Access Compliance Report

Public Rights-of-Way

Intersection ID: 18583	Main Street: BURTONWOOD_CR	Cross Street: MONROE_RD	Location: SW
ADA ID: 53BAC0A575F0	Ramp Type: PerpDiag	Initial Pass/Fail: Fail	Overall Compliance: No
		Severity Score: 25

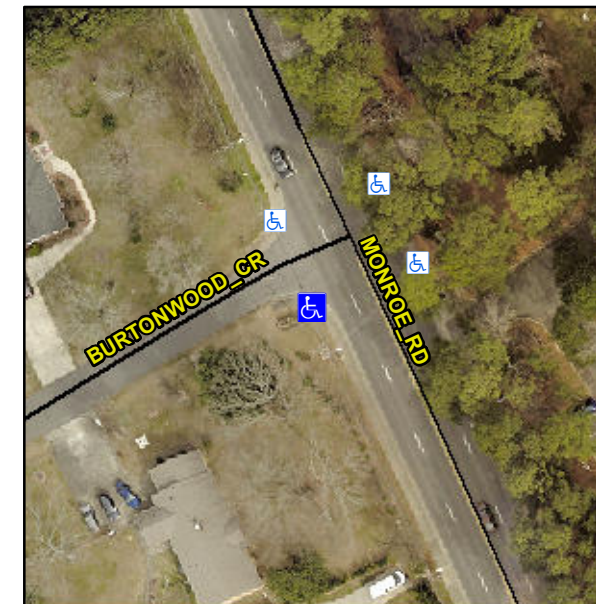
Not Found, R304.2.2, R304.5.3

Compliance	Description	Data	Compliance	Description	Data
N/A	Ramp Length (in)	57.0	No	Ramp Slope (%)	11.6
Yes	Ramp Width (in)	48.0	No	Ramp XSlope (%)	6.3
N/A	Flare Type LT	N/A	N/A	Flare Type RT	N/A
N/A	Flare Slope LT (%)	N/A	N/A	Flare Slope RT (%)	N/A
N/A	Flare Traversable LT?	N/A	N/A	Flare Traversable RT?	N/A
N/A	Landing Length (in)	N/A	N/A	DWS Provided?	N/A
N/A	Landing Width (in)	N/A	N/A	DWS Contrast?	N/A
N/A	Landing Slope (%)	N/A	N/A	DWS Length (in)	N/A
N/A	Landing X Slope (%)	N/A	N/A	DWS Full Width?	N/A
N/A	Landing Curb? (Y/N)	N/A	N/A	DWS Offset (in)	N/A
N/A	Shared Landing?	N/A			
N/A	Gutter Ponding?	N/A	N/A	Gutter Slope (%)	N/A
N/A	Gutter Lip Ht (in)	N/A	N/A	Gutter X Slope (%)	N/A
N/A	Painted X Walk1?	No	N/A	Painted X Walk2?	No
	X Walk 1 Direction	To E		X Walk 2 Direction	To N
N/A	X Walk 1 Width (in)	N/A	N/A	X Walk 2 Width (in)	N/A
	X Walk 1 Slope (%)	3.0		X Walk 2 Slope (%)	0.1
	X Walk 1 X Slope (%)	1.2		X Walk 2 X Slope (%)	3.2

Remove & Replace Curb Ramp With Two New Directional Ramps or Equivalent.
